Job: TH - Walled Garden Buildings

Title: Buildings 16 & 16a - North & South Elevations P2

Status: FOR PLANNING

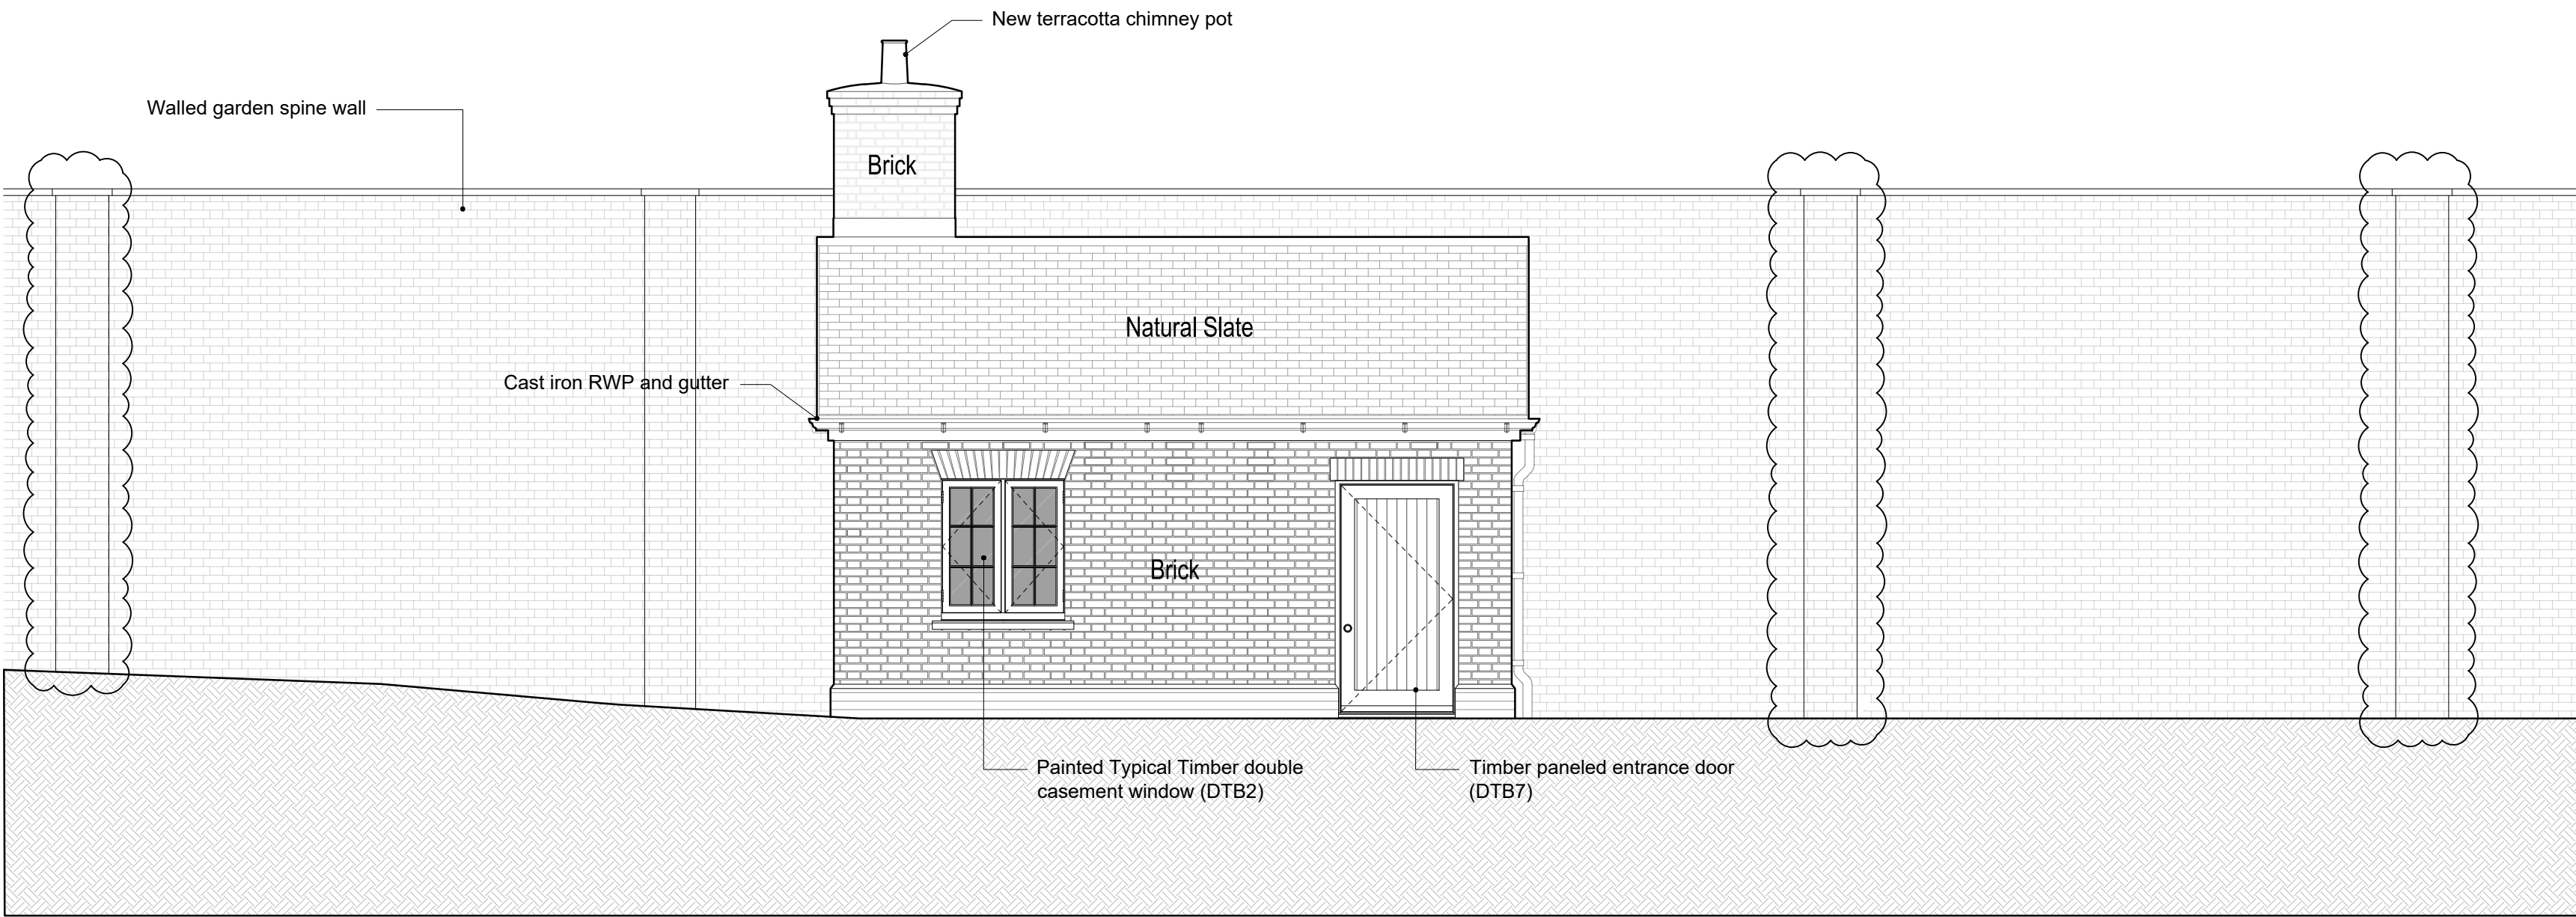
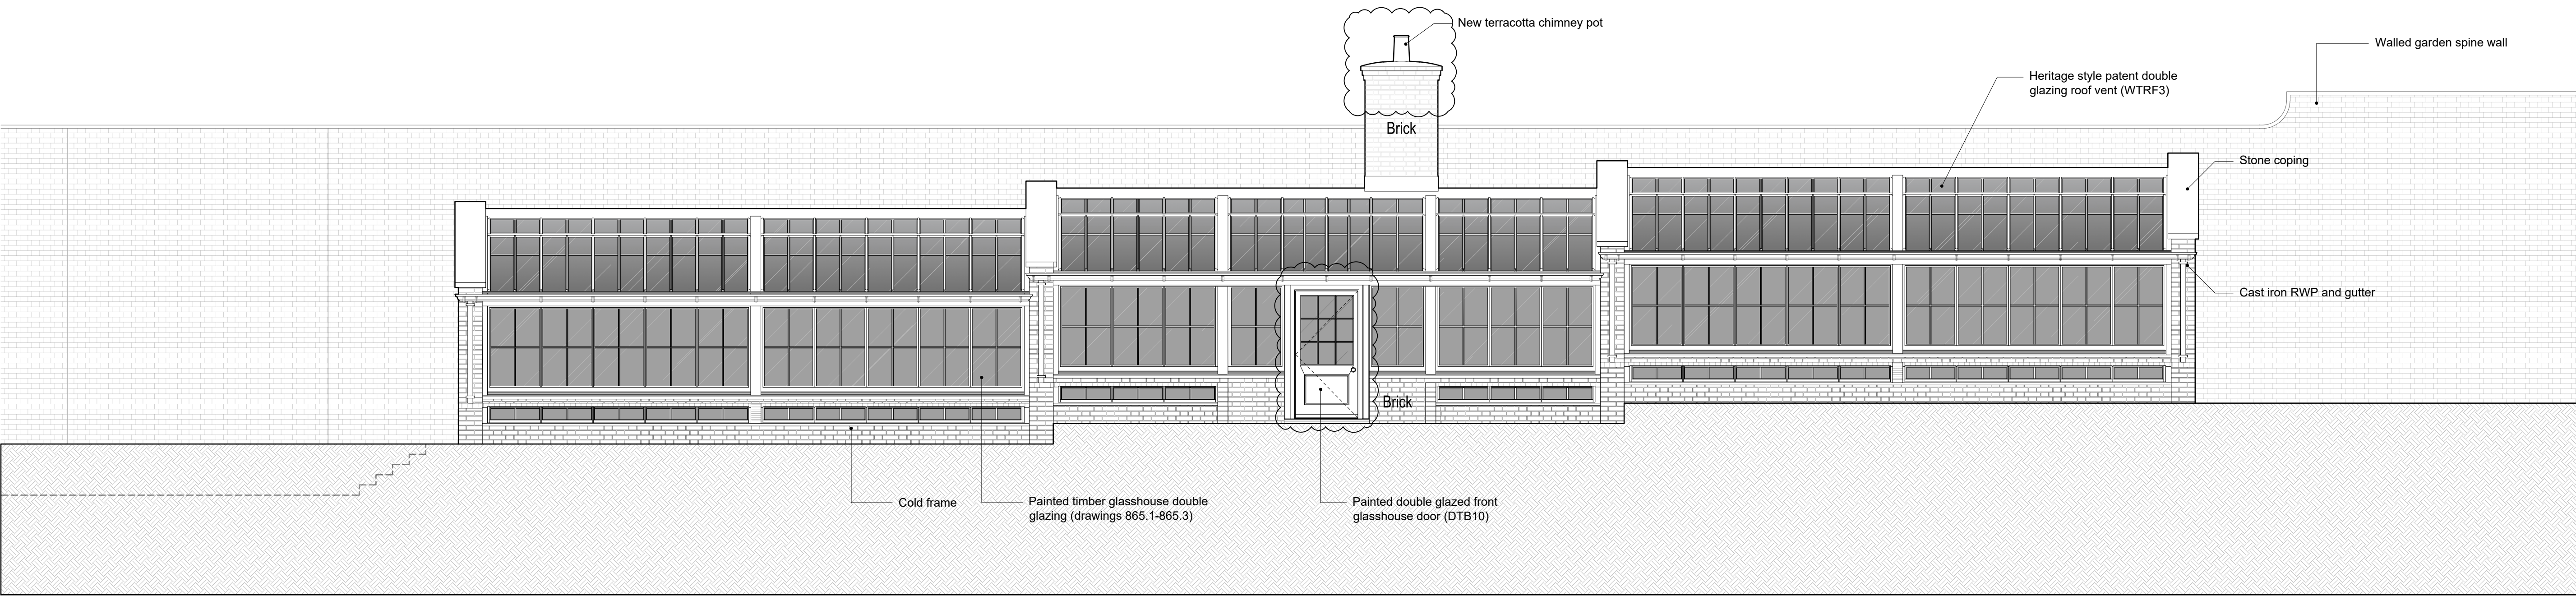
P2	Natural slate noted as Officers' comments. Glazing bar type and chimney amended. Spine Wall piers added back	22/04/26	checked by	DY	approved by	DY
P1	Initial Release	dd/mm/yy	scale	1:50 @ A1	size	A1
no.	revision.	date.	job number	3124	drawing number	242
					revision	P2
					date.	30/03/26
